HISTORIC AND DESIGN REVIEW COMMISSION

August 21, 2024

HDRC CASE NO: 2024-267
ADDRESS: 2619 MCCULLOUGH AVE
LEGAL DESCRIPTION: NCB 1704 BLK 12 LOT N1-2 OF 12 & 13
ZONING: O-1, H
CITY COUNCIL DIST.: 1
DISTRICT: Monte Vista Historic District
APPLICANT: Matthew Gilbert/Ortiz McKnight PLLC
OWNER: ZUNIGA LAW PLLC
TYPE OF WORK: Requesting a waiver, fenestration modifications
APPLICATION RECEIVED: July 19, 2024
60-DAY REVIEW: September 17, 2024
CASE MANAGER: Claudia Espinosa

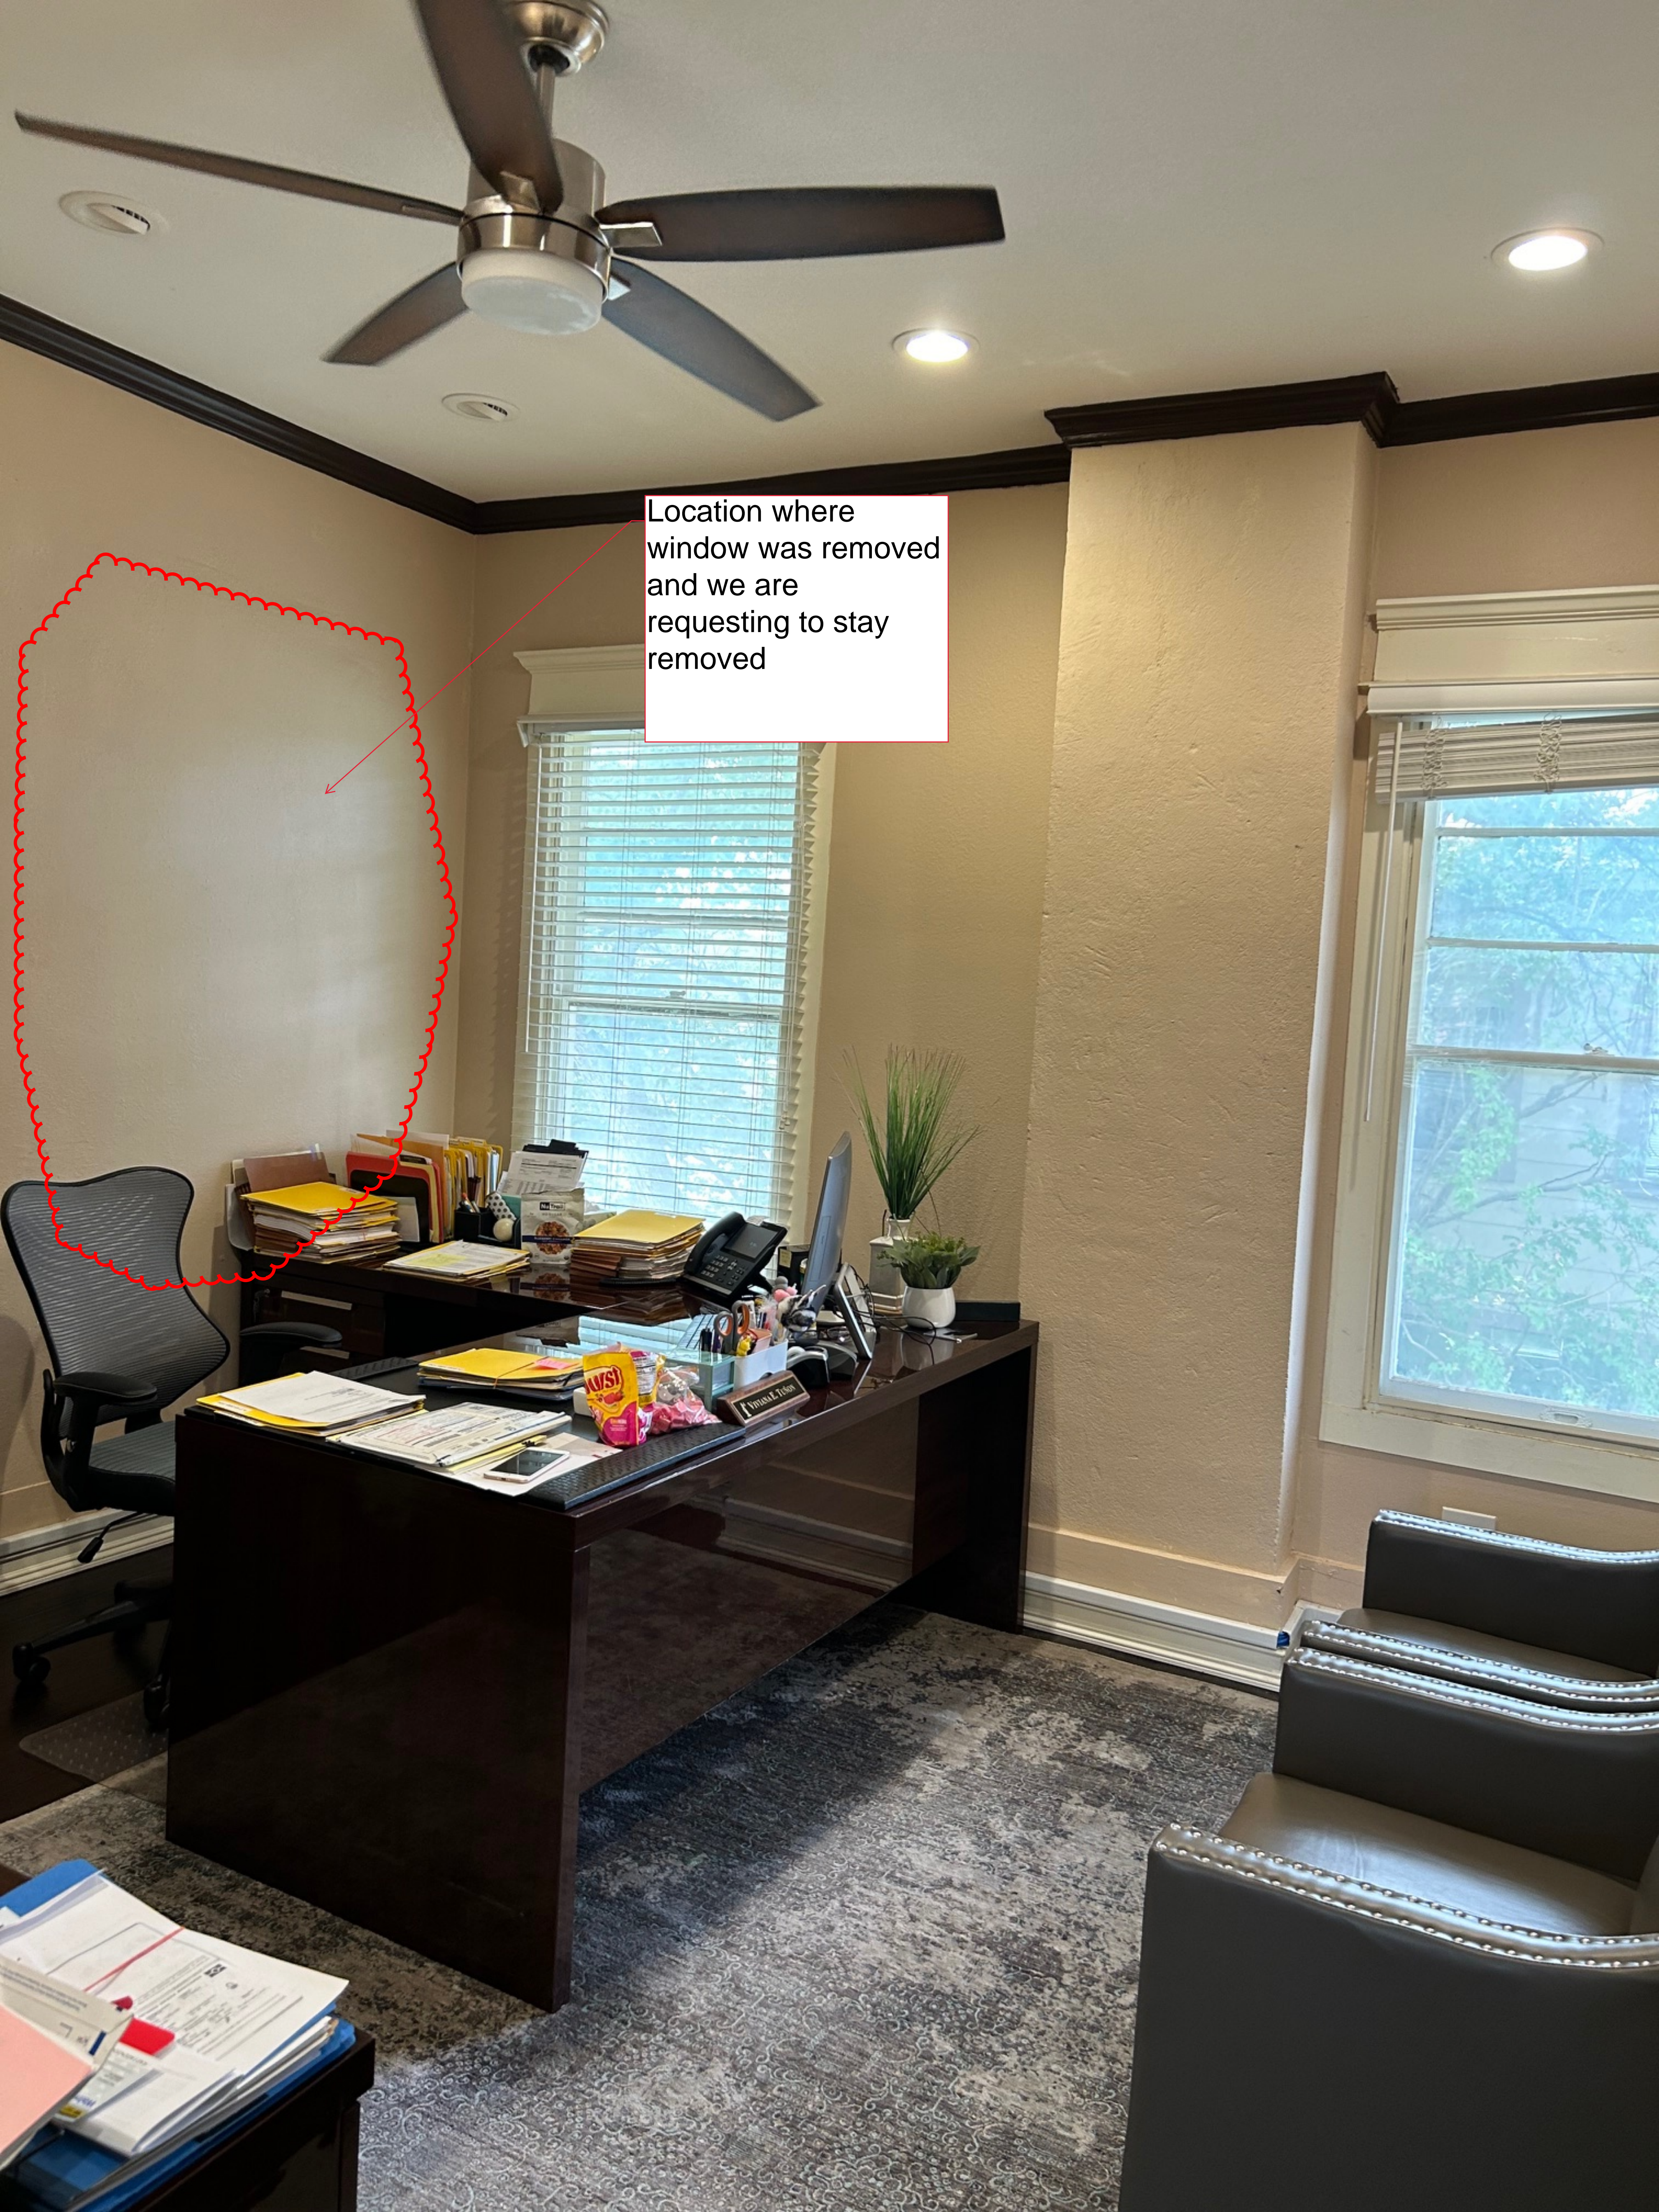
Location of
request to
have siding
remain

Location of 3
re-built
wooden
windows

Locations of
2 of the
requested
new wooden
screens

Location of 3
re-built
wooden
windows

Location of remaining 3 windows requested for new wooden screens

Location where
window was removed
and we are
requesting to stay
removed

- i. Approval to retain the five altered window openings on the south face with the stipulation that appropriate one over one sash windows are installed instead of a fixed window based on finding d. The proposed window screens are appropriate and may be installed regardless of commission disposition regarding the window product. If the HDRC approves retention of the fixed windows, then staff recommends the window screens be required.
- ii. Staff does not recommend approval of the window infill east elevation based on finding e. Staff recommends that the applicant restore the window opening with a salvaged window or replacement product that matches in size, operation, design, and configuration.

EXHIBIT
5

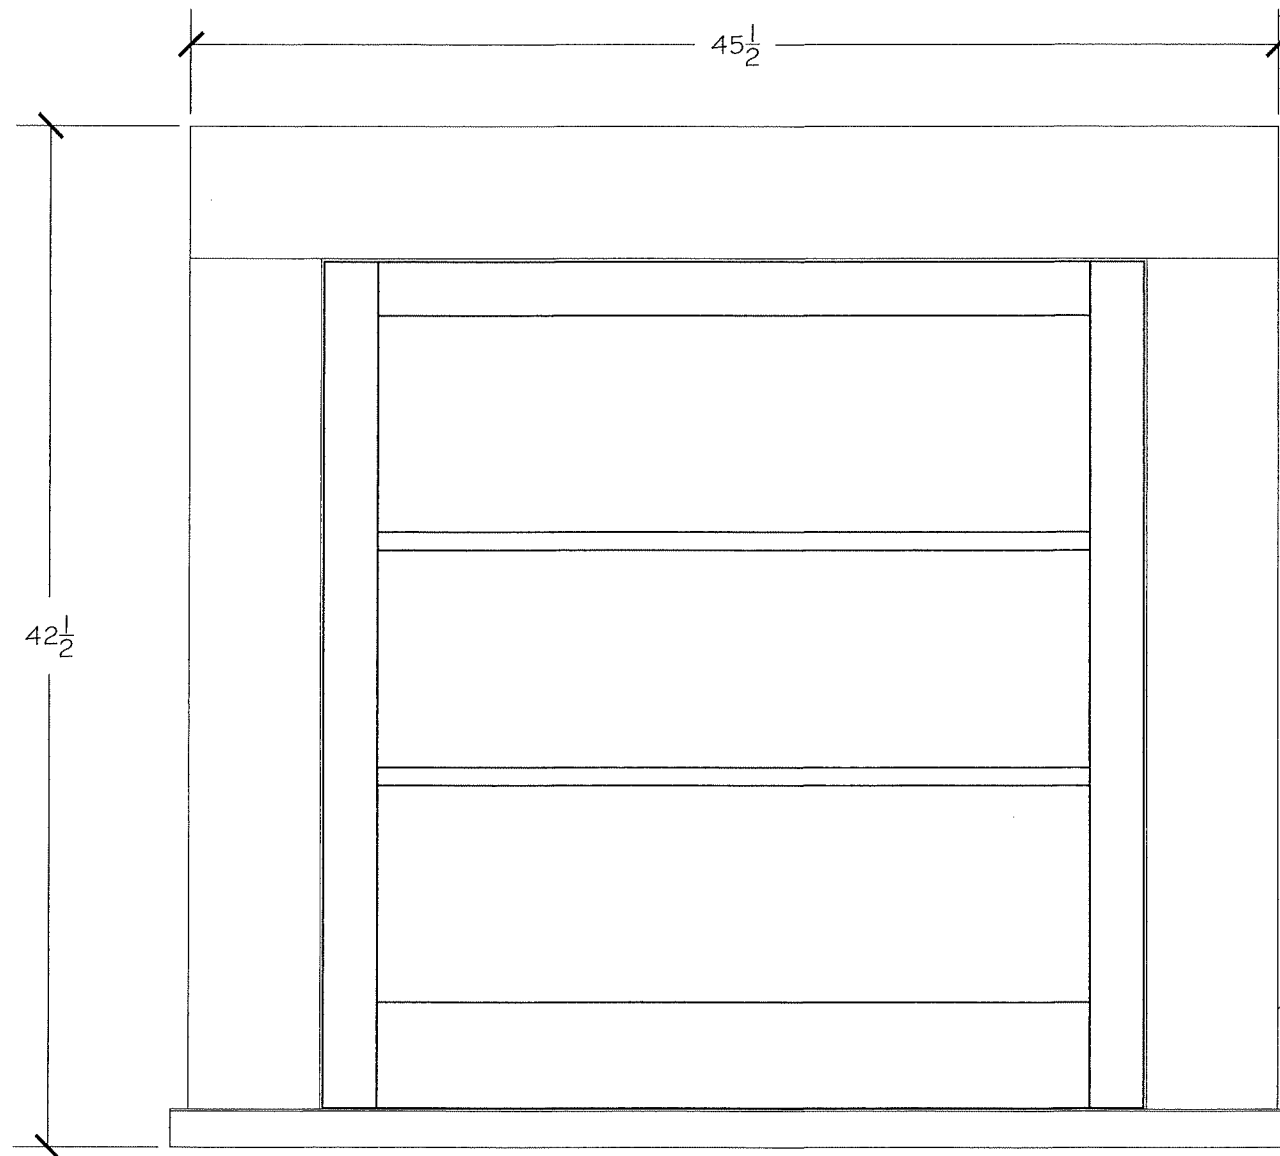
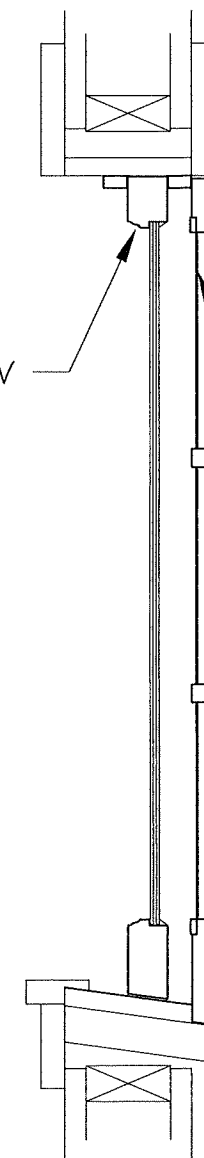
EXTERIOR VIEW

EXISTING REPLACEMENT WINDOW

EXISTING ORIGINAL TRIM

NEW WOOD WINDOW SCREEN.
INSTALLED TO CONCEAL WINDOW

3/4" HORIZONTAL MUNTINS

Modifications on the south facade, circa 2024

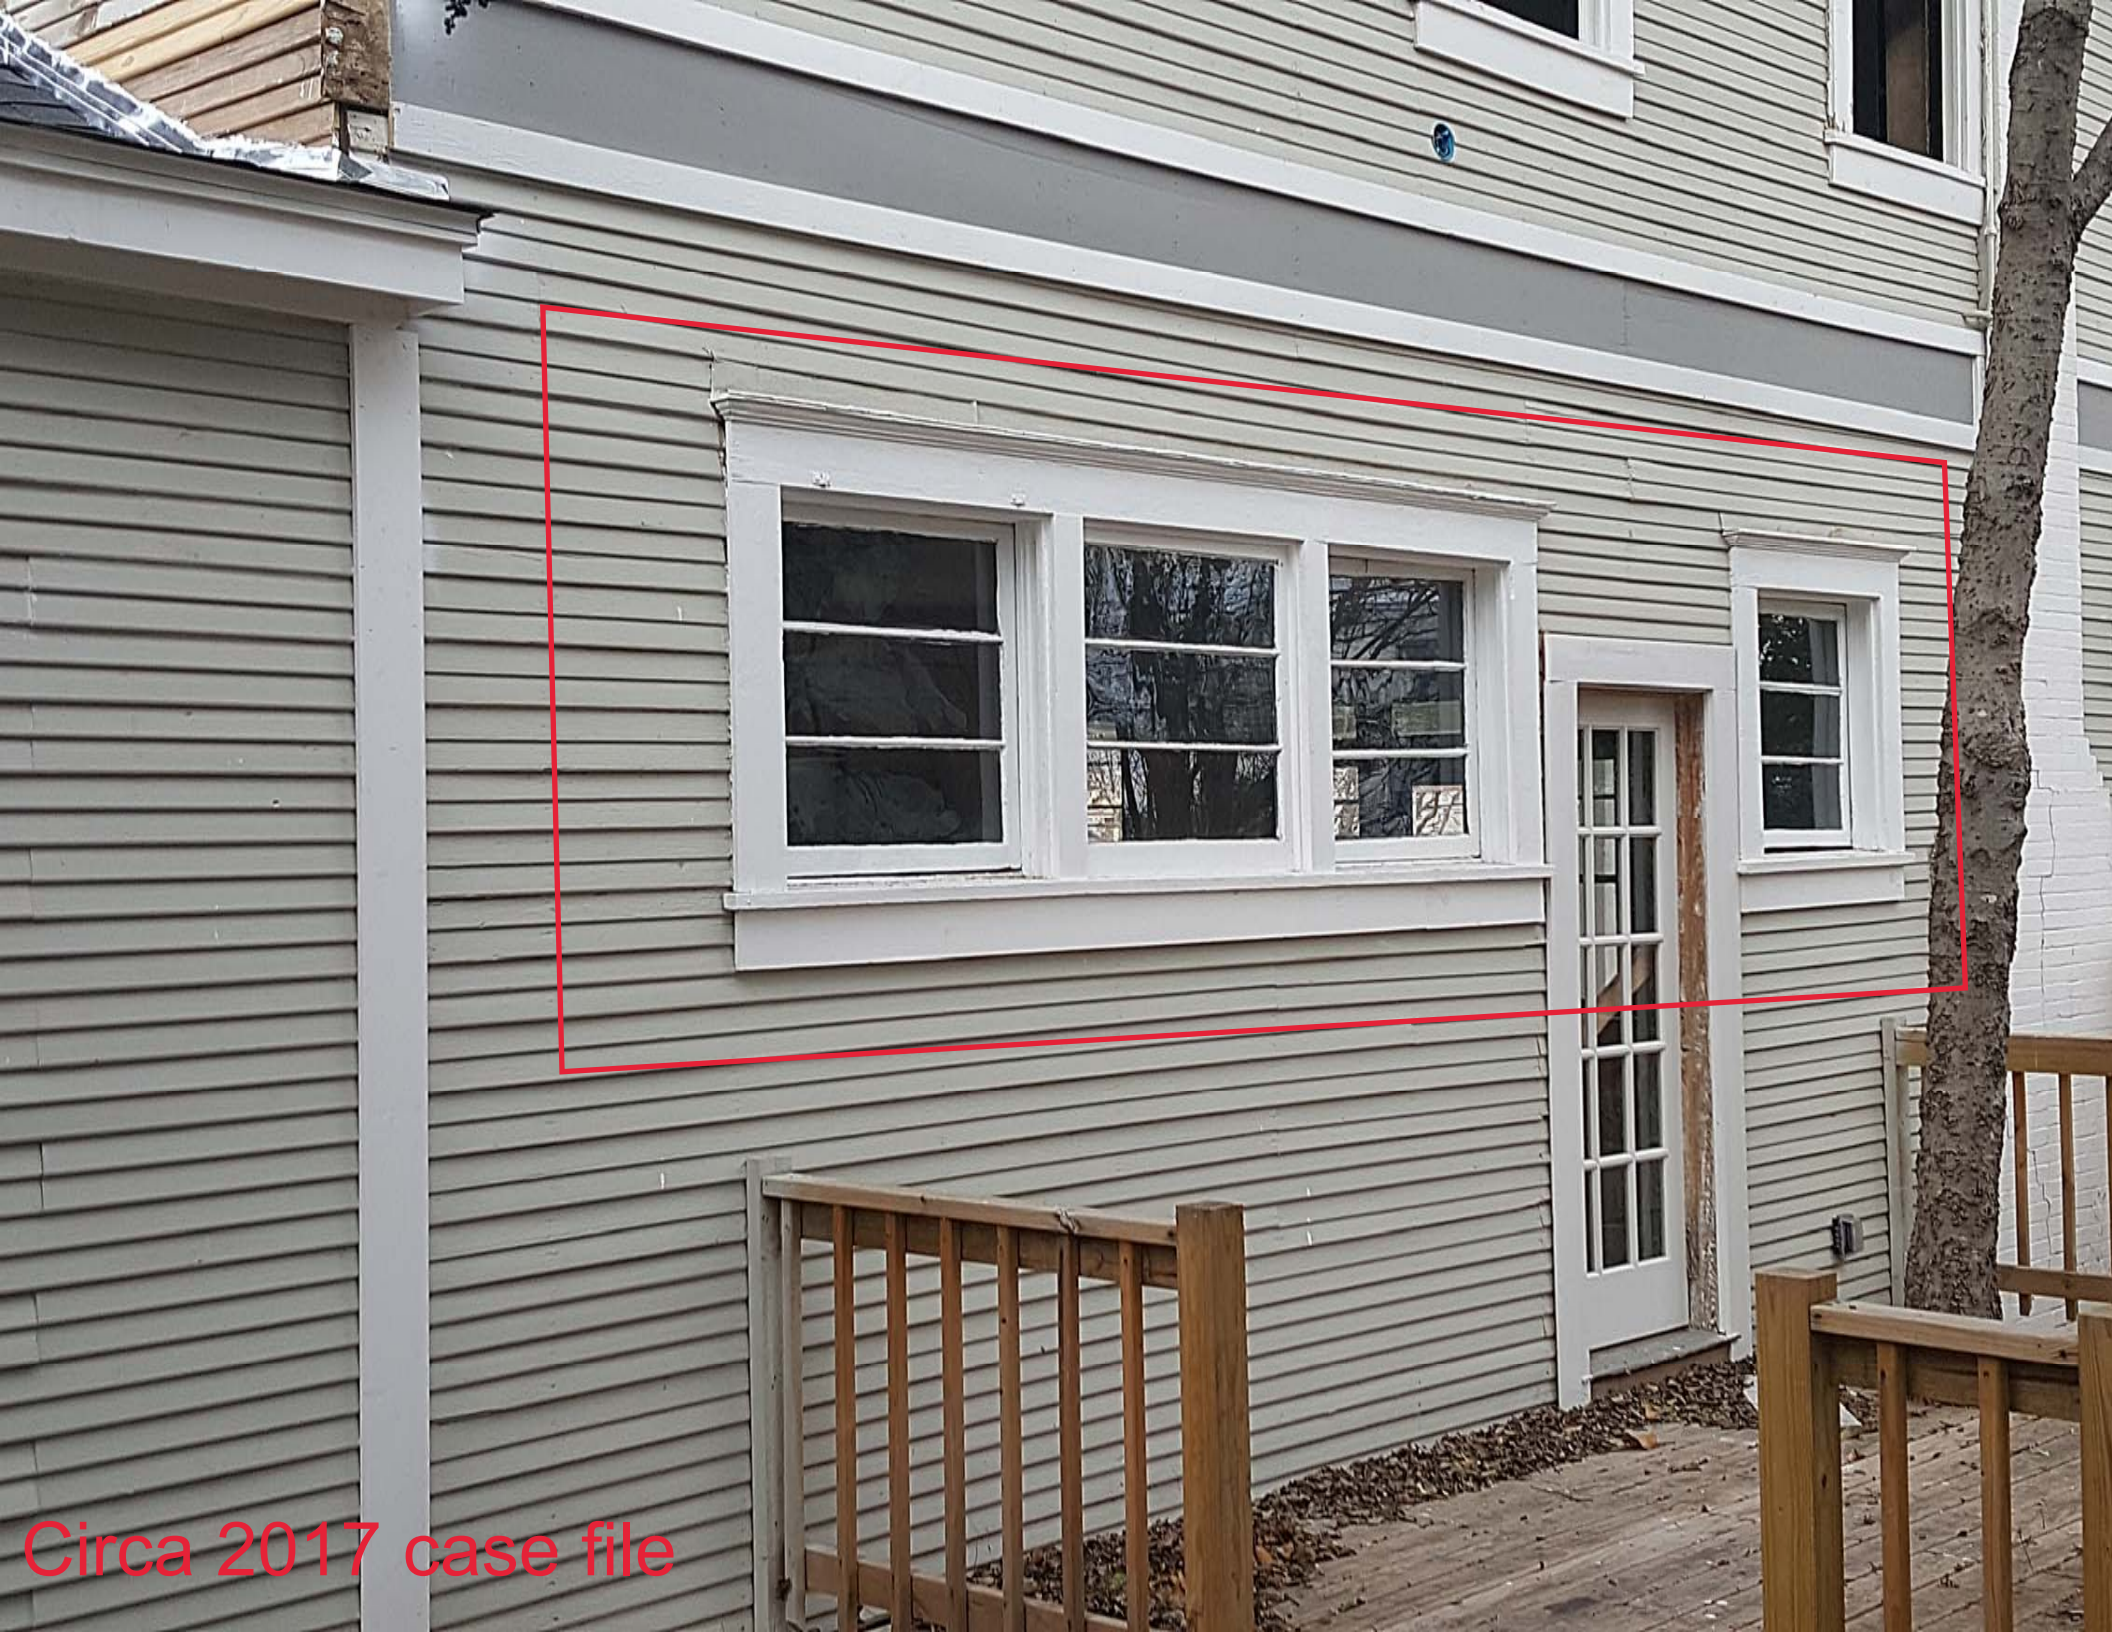
- d. **WINDOW OPENING MODIFICATION (SOUTH FACADE)** – The applicant has proposed to replace five (5) window openings on the south facade and shorten the overall size of two of the openings. As a revision to the original proposal, the applicant has proposed to install wood window screens onto the replacement windows. The Guidelines for Exterior Maintenance and Alterations 6.A.i. notes that historic window and door openings should be preserved and discourage the modification of window sizes. It is unclear if the windows at this location were original prior to their removal; sash windows were likely the original condition on this facade. Similar, smaller sashed windows are located on the north facade and may be used as a reference. Staff finds that modifications to these openings are generally appropriate provided that any replacement windows are consistent with the Guidelines. The installed fixed windows are not consistent with the Guidelines. The applicant has proposed wood screens to disguise their appearance.
